SERVICE NO. 1350 BULLETIN

Date: December 17, 2020

**NOSE LANDING GEAR STEERING HORN AND ARM
ASSEMBLIES INSPECTION**

PA-46-350P M350
PA-46-500TP M500
PA-46-600TP M600

DETAIL B
STEERING HORN BASE (TYPICAL)
(VIEW ROTATED 90 DEGREES CW)

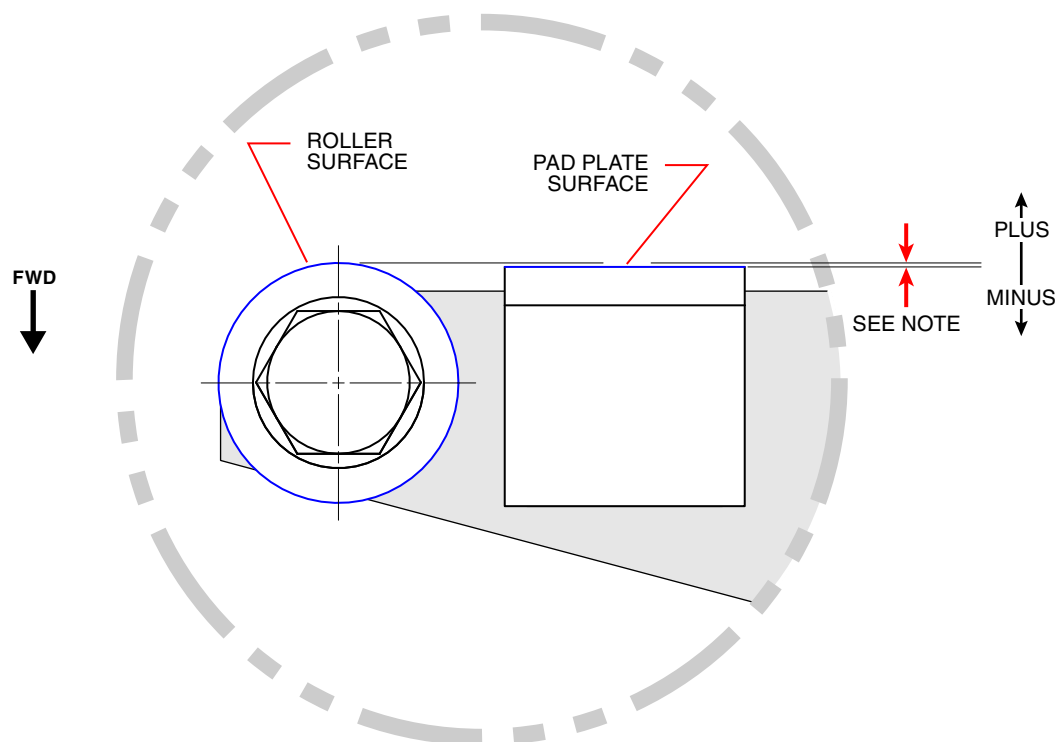
- a. Remove and discard the safety wire retaining the three bolts that attach the steering horn base to the trunnion.
 - b. Loosen and remove the three Bolts AN4H5A and Washers NAS1149F0463P. Retain the hardware for reinstallation; replace any hardware, depending on condition.

- c. Remove the Nose Wheel Steering Horn Assembly, P/N 85154-012. Do not remove the two Rollers, P/N 83638-002 and P/N 83638-006, from the assembly.
3. Visually inspect the steering horn pads and rollers for any signs of damage.

NOTE: Torque Bolts AN4H5A to 25–30 in-lb.

- 2) Install P/N 46N32A009-801 onto the trunnion assembly, as shown in in Detail B. Torque the bolts per the note in Detail B. Safety wire the bolts with P/N 151-296 (MS20995-C32).

- 2) Install the hardware retained in Step 2, and torque the bolts per the note in Detail B. Safety wire the bolts with P/N 151-296 (MS20995-C32).
- c. Replace the steering arm assembly, if required.

DETAIL C

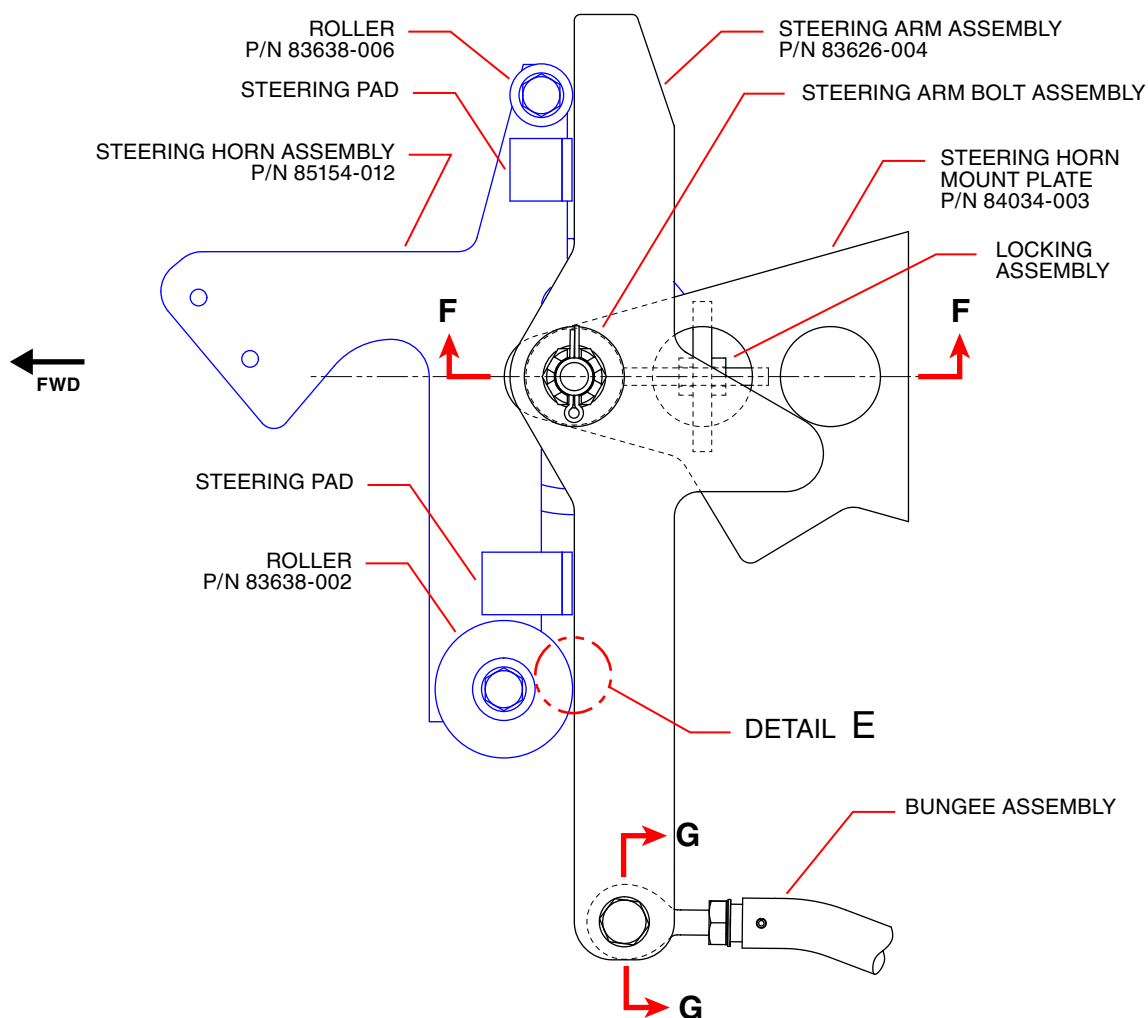
- If there is no visually apparent damage, then proceed to Step 4.
 4. Check if the steering pads and rollers are positioned correctly on the steering horn as shown in Detail C. Place the steering horn onto a flat surface, with the rollers facing the surface. Use a feeler gauge, or a shop aid of appropriate thickness, to determine if the parts are positioned as depicted in Detail C.

NOTE: Detail C provides the correct positioning of the rollers and pads on both the existing and replacement steering horn.

- If the steering pads and rollers are not positioned as Detail C shows, then the parts must be replaced, which will be accomplished in an upcoming step. Proceed to Step 5.
 - If the steering pads and rollers are positioned as Detail C shows, then it may not be necessary to replace the steering horn assembly and rollers. Proceed to Step 5.
5. Inspect the Arm Assembly, P/N 83626-004, for any signs of damage, especially in the areas where the steering pads make contact.

NOTE: The surface of both rollers must be positioned between plus 0.020 in. maximum and minus 0.001 in. maximum distance from the surface of both steering pad plates. The acceptable distance is applicable to both sides at the same time.

DETAIL E

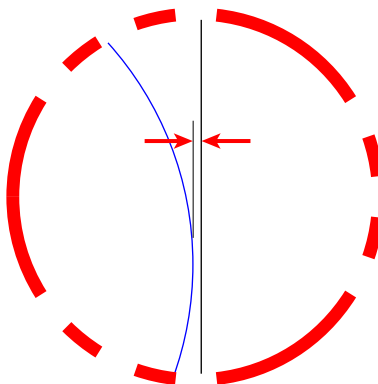
NOTE: The clearance between the steering arm and both of the rollers must be 0.010 – 0.030 inch.

VIEW F-F
STEERING ARM BEARING BOLT STACK-UP AND JAM NUTS

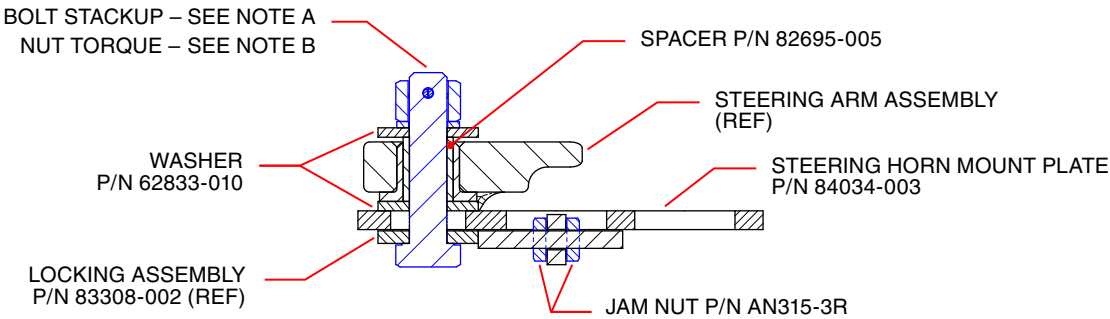
- b) From the bolt assembly common to the steering arm and the mount plate, shown in View F–F, remove the cotter pin, nut and washer that fasten the steering arm to the mount plate. Discard the cotter pin and retain the other hardware; replace any hardware, depending on condition.

- c) Lift the steering arm assembly off of the bolt.
 - 3) Install the new, replacement Steering Arm Assembly, P/N 83626-004:
 - a) Position the replacement steering arm assembly on the bolt (AN6-15 for M600, or AN6-14A for M350 and M500). Ensure that the bolt hardware stack-up is exactly as defined, for the appropriate model, in View F–F. Replace any hardware on condition.

NOTE A: The bolt stackup, by models:

For M600 (shown):	For M350 and M500:
BOLT AN6-15	BOLT AN6-14A
WASHER NAS1149F0663P	NUT MS21042-6
NUT MS17825-6	
COTTER PIN MS24665-283

NOTE B: For M600 only, torque the Nut MS17825-6 to 100 in-lb, then back off to the nearest radial slit.
For M350 and M500, torque the Nut MS21042-6 to 175-190 in-lb.

Figure 2

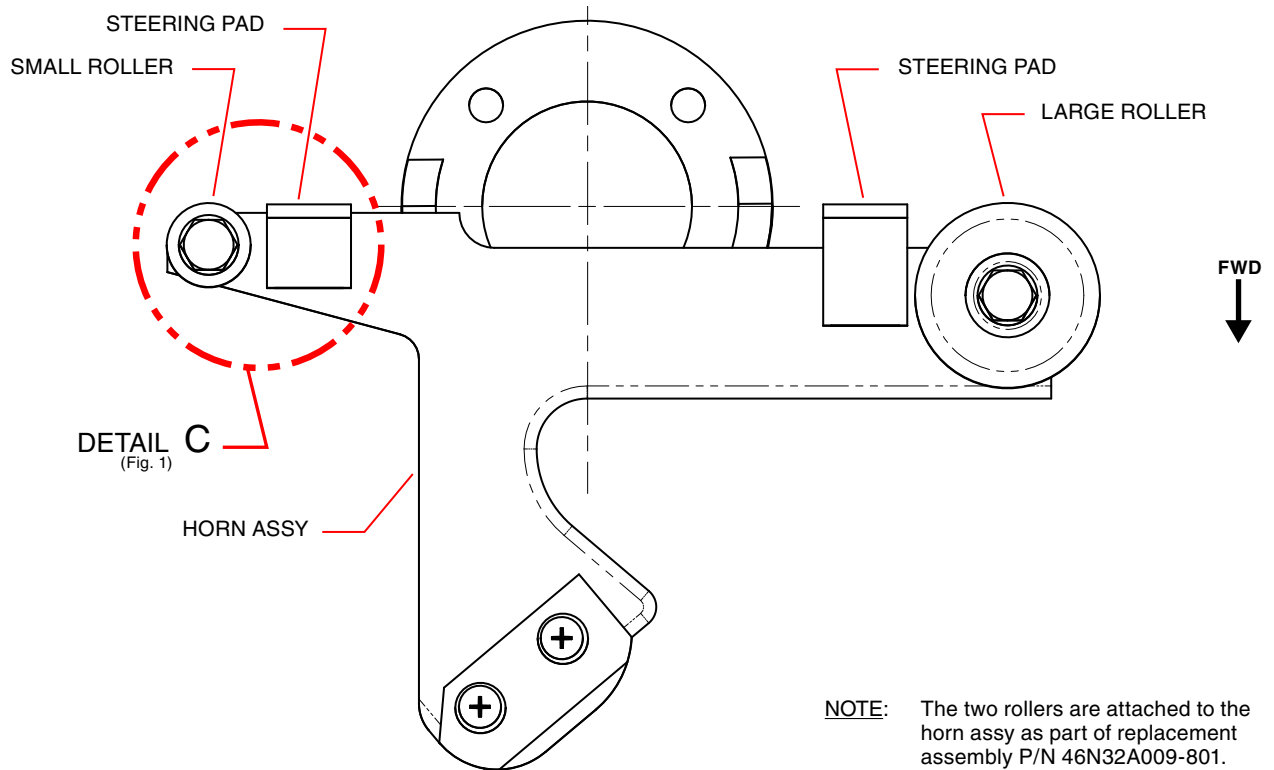
- 1) Order one (1) Nose Wheel Steering Horn and Roller Assembly, P/N 46N32A009-801, which is shown in Figure 2. This new, improved assembly replaces, as one assembly, the existing steering horn assembly (which includes the steering pads) and steering horn rollers.
